Year Three Monitoring Report

GROUNDHOG HOLLOW PROJECT

RE: Groundhog: Year 3 Monitoring Report (NCDMS ID 100049)

Listed below are comments provided by DMS on February 9th, 2024 regarding the Groundhog Mitigation Site: Year 3 Report and RES' responses highlighted in blue.

2023 Groundhog Hollow GF3 Stage Recorder Graph

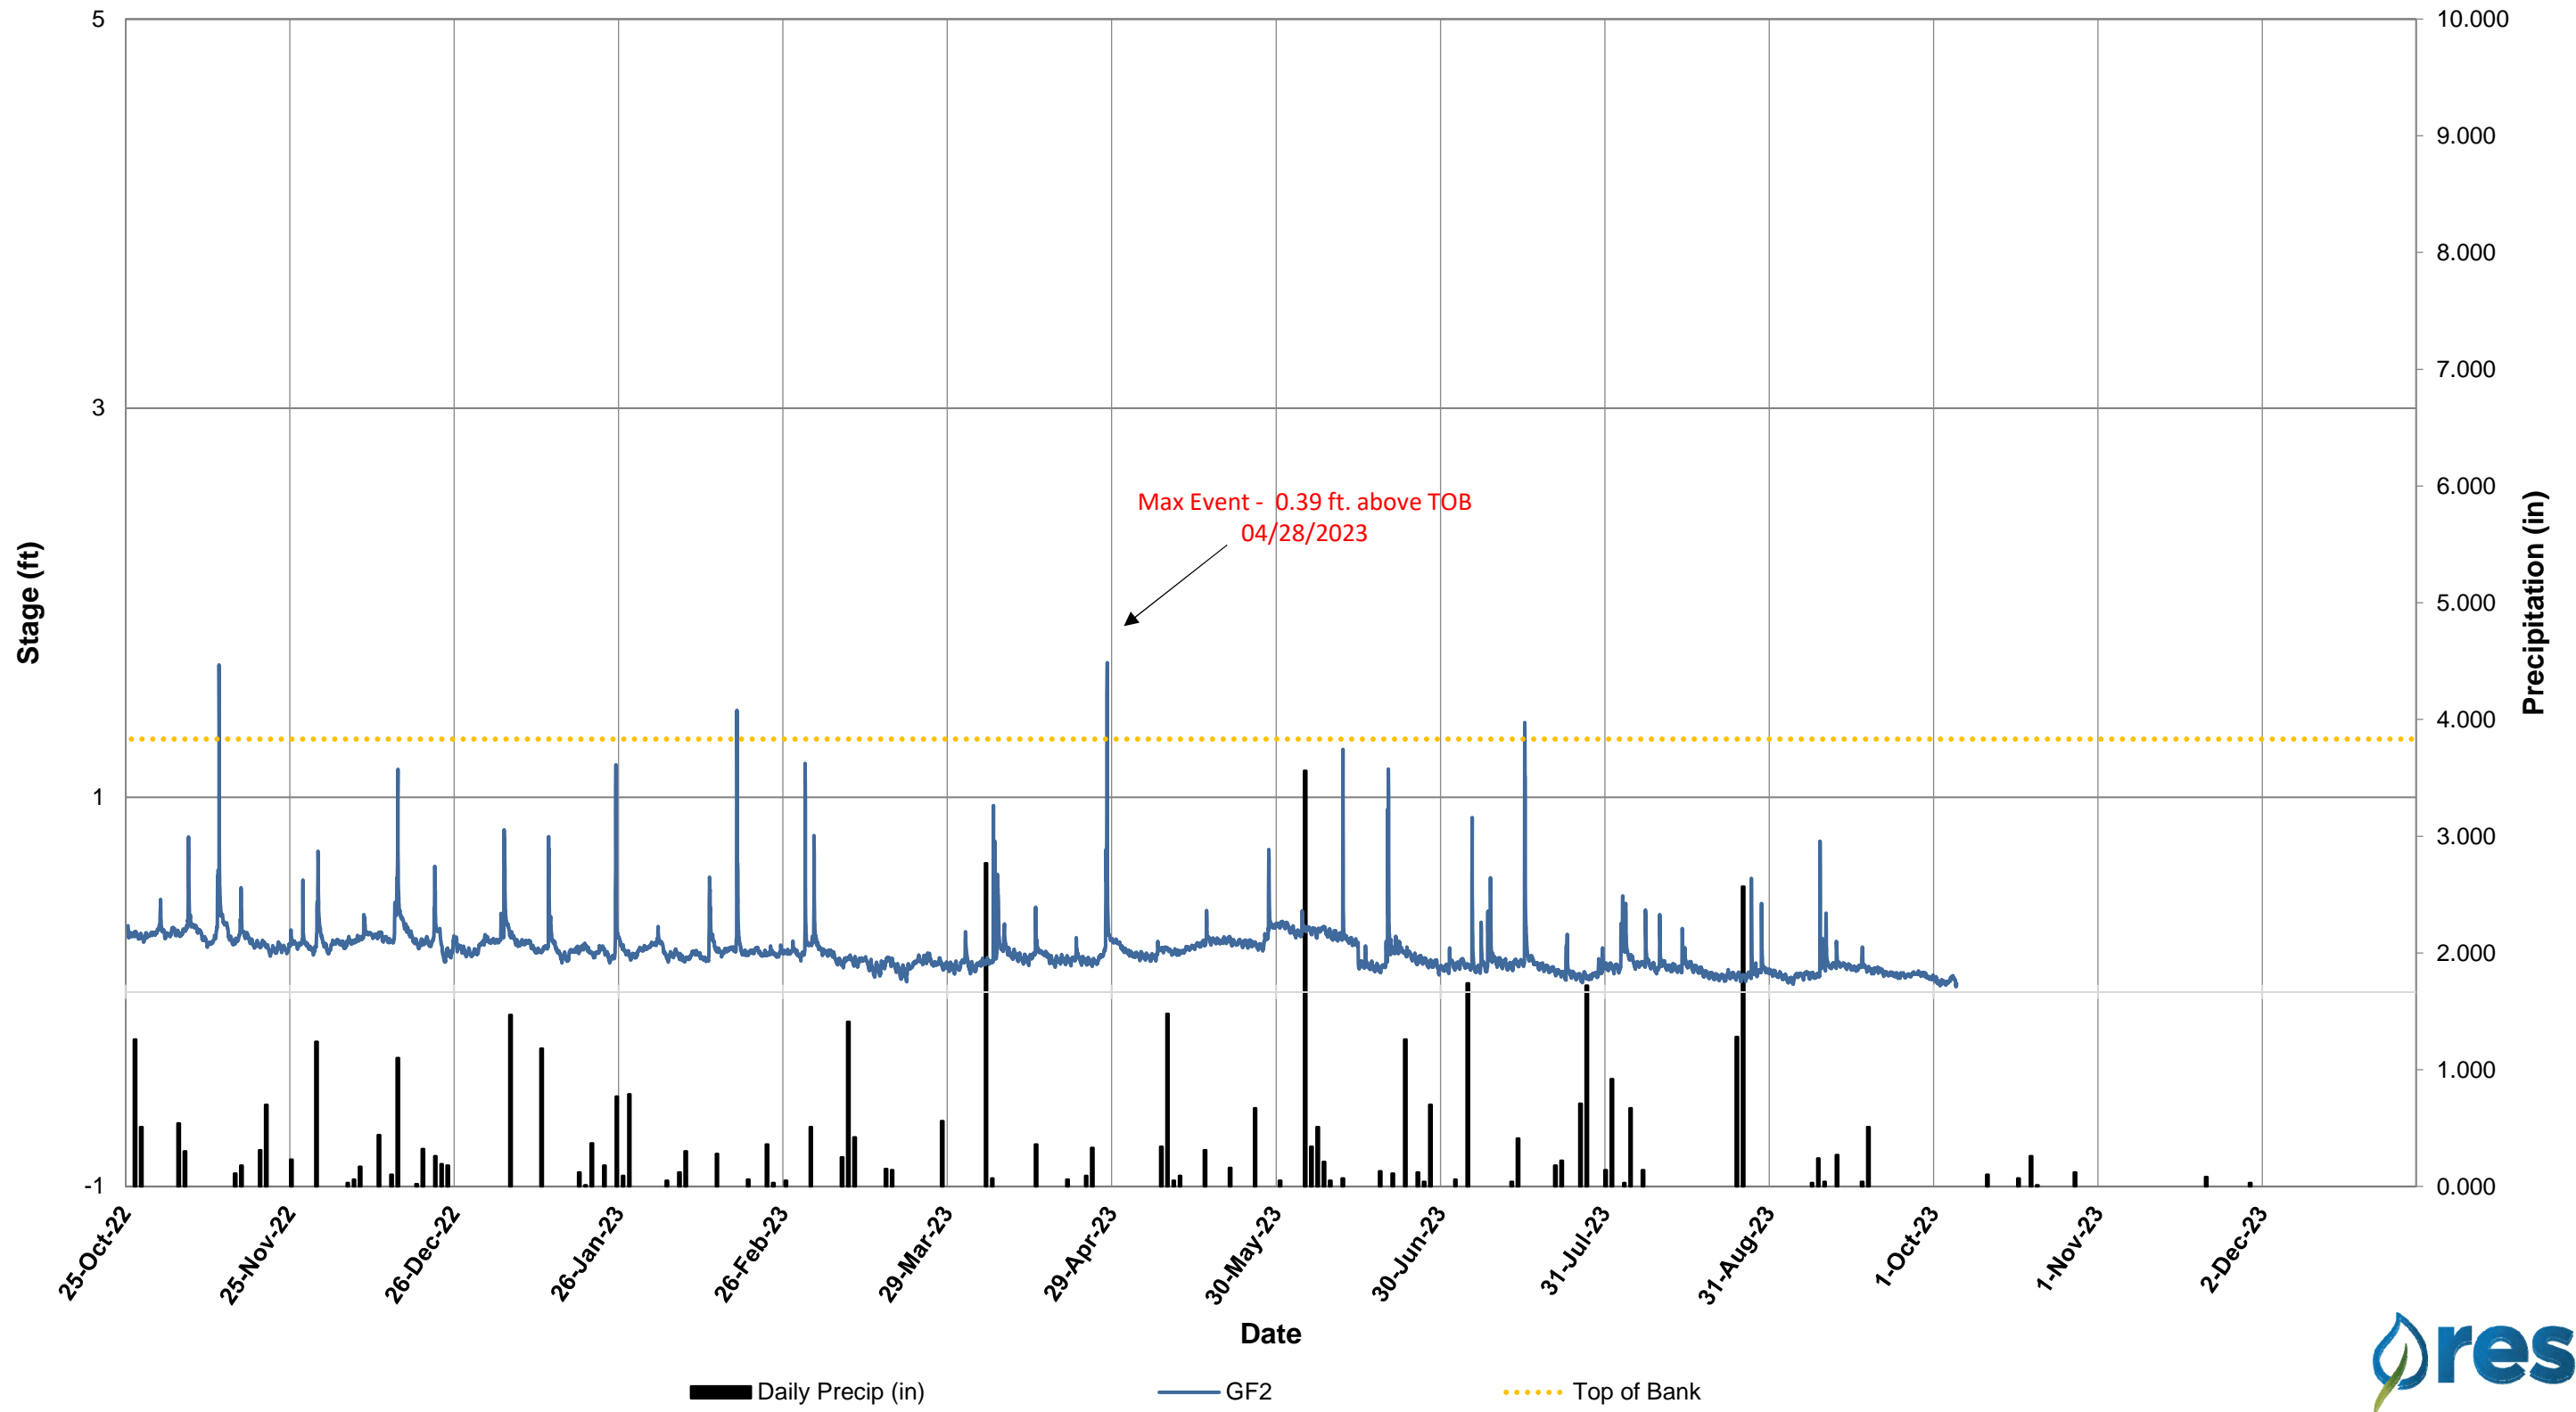
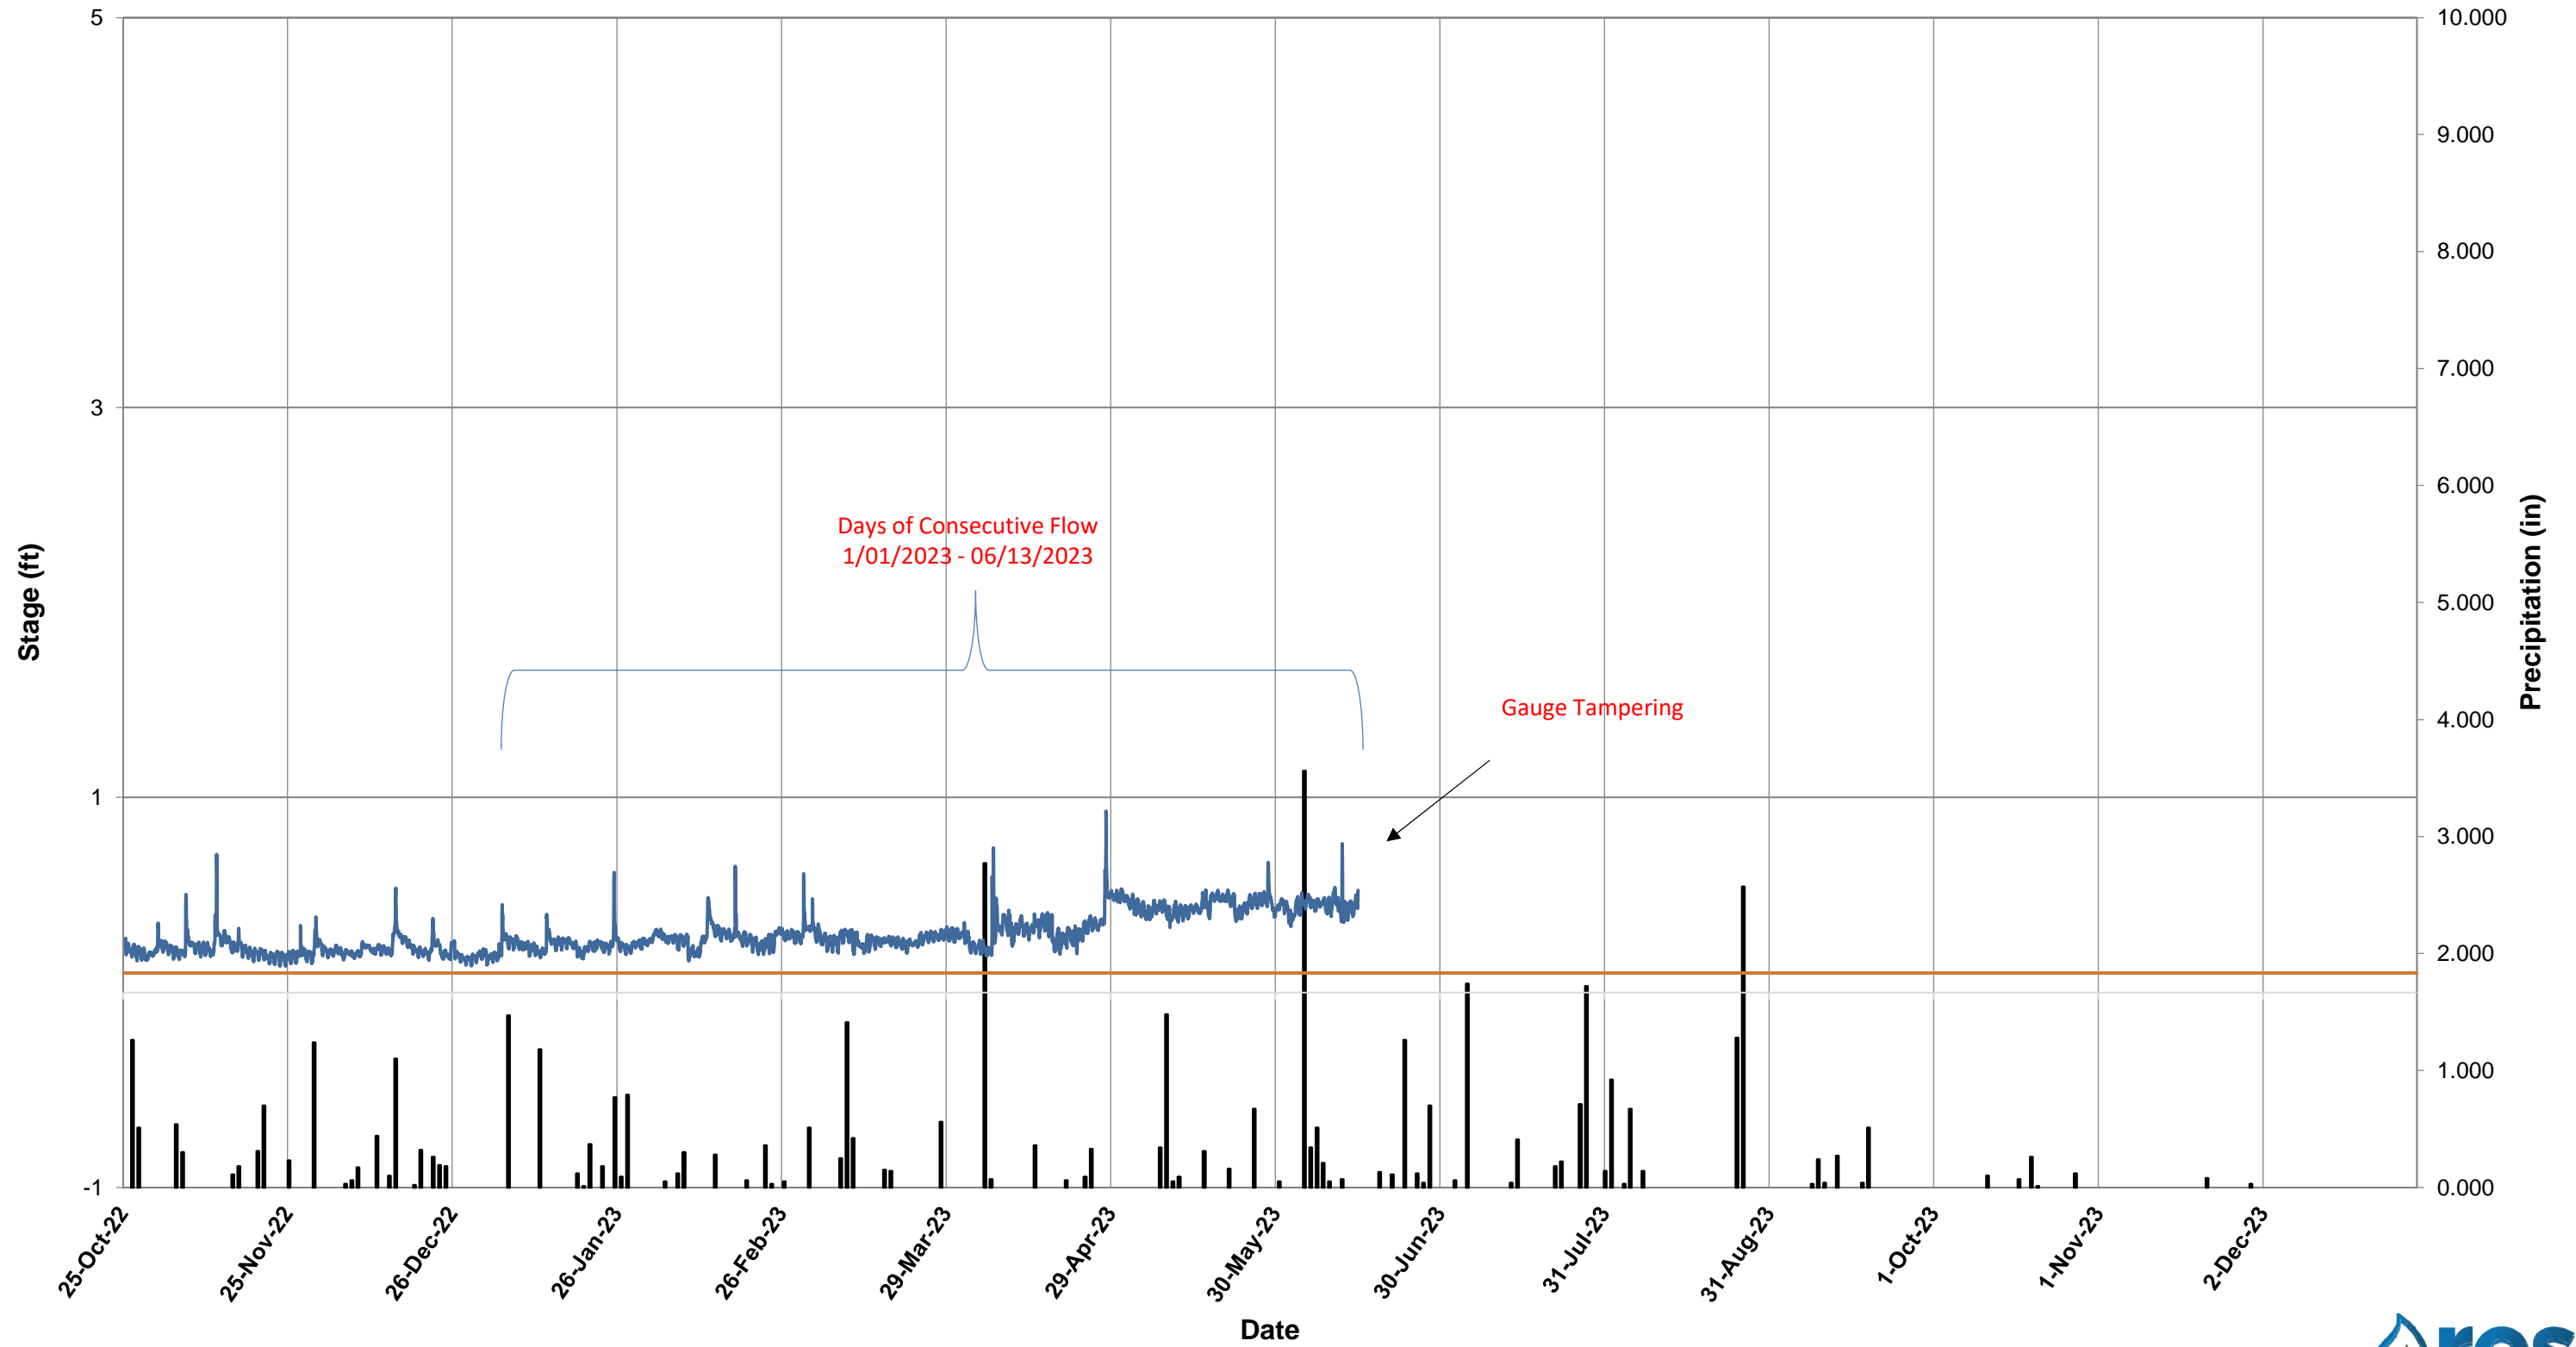
- The surface water graphs submitted were mislabeled as MY 2; the data appeared to be MY3 2023. Please review, verify and update accordingly. For future submissions, please check to ensure the data tables and graphs are labeled correctly.

- The labels for the MY3 2023 hydrographs have been updated and are included in the digital support files.
